CRMC DECISION WORKSHEET

2024-03-112

Pistocco Irrevoc. Trust

**STATE OF RHODE ISLAND
COASTAL RESOURCES MANAGEMENT COUNCIL
STAFF REPORT TO THE COUNCIL**

Portion of submitted site plan

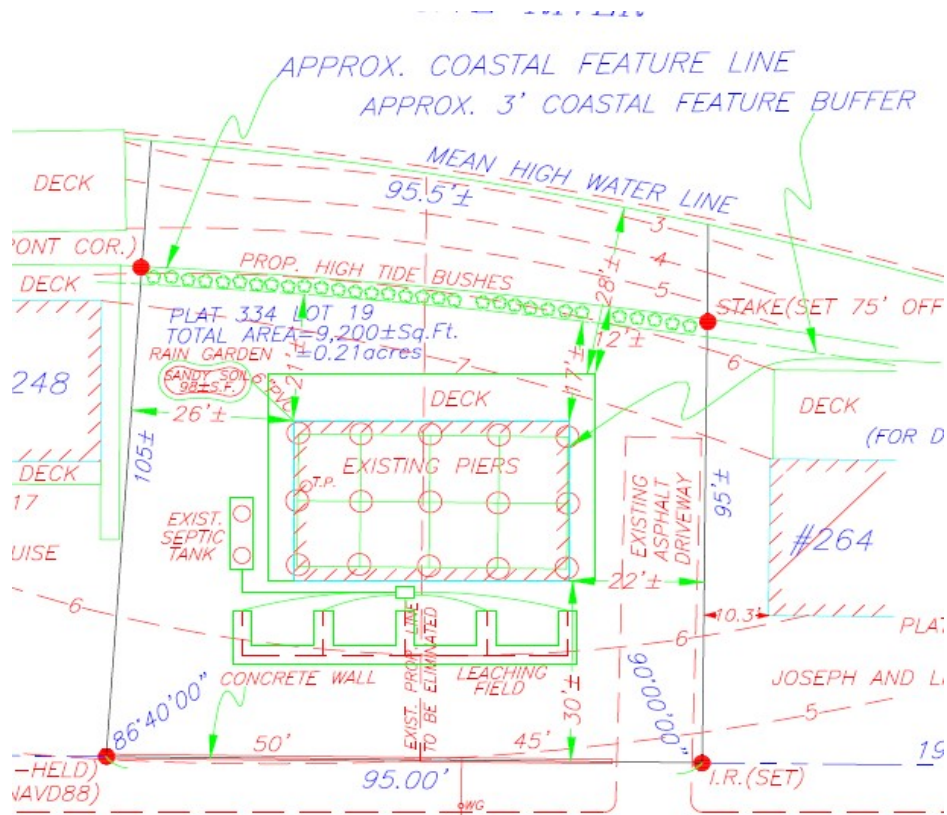
As submitted, the applicant has proposed a 3 foot Buffer Zone consisting of a single row of High Tide Bush (*Iva frutescens*/88% Variance) and a variable width Setback of 12-17 feet. There is a deck proposed on three sides of the dwelling which will extend into the Setback – Setback measurements are from the Coastal Feature to the foundation pilings.

sewer line. It should be noted however, that the submitted site plans do not depict the sewer tie in. This shall be added by stipulation should the Council approve this application.

The structure shall be connected to municipal sewer service. Utilization of the existing OWTS on site shall not be allowed.

Above: (l) Subject lot with 3' SLR flooding and (r) with 7' SLR flooding

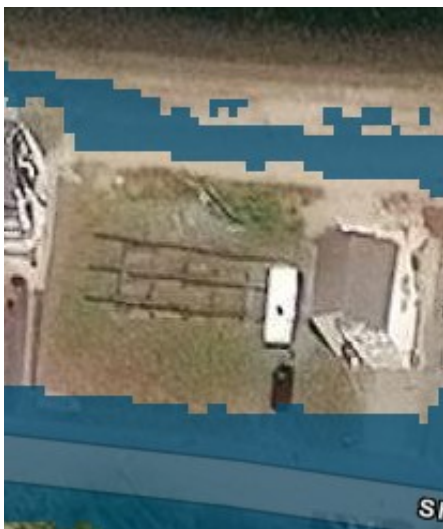
- The applicant is advised that the CERI risk index for this area under a 3' SLR scenario is "Extreme". For the 7'/100 year scenario is CERI risk is "100%/ Inundated". Please see <http://www.beachsamp.org/stormtools/stormtools-coastal-environmental-risk-index-ceri/> for details on the CERI Risk Index

The noted erosion rate nearest the site is .2ft/yr, giving an erosional setback that is less than the standard 50 foot construction setback. As proposed, the dwelling pilings are sited approximately 20-24 feet from the Coastal Feature. Within 30 years, this site can be expected to lose approximately 6 feet of land, leaving a setback of 11-18 feet.
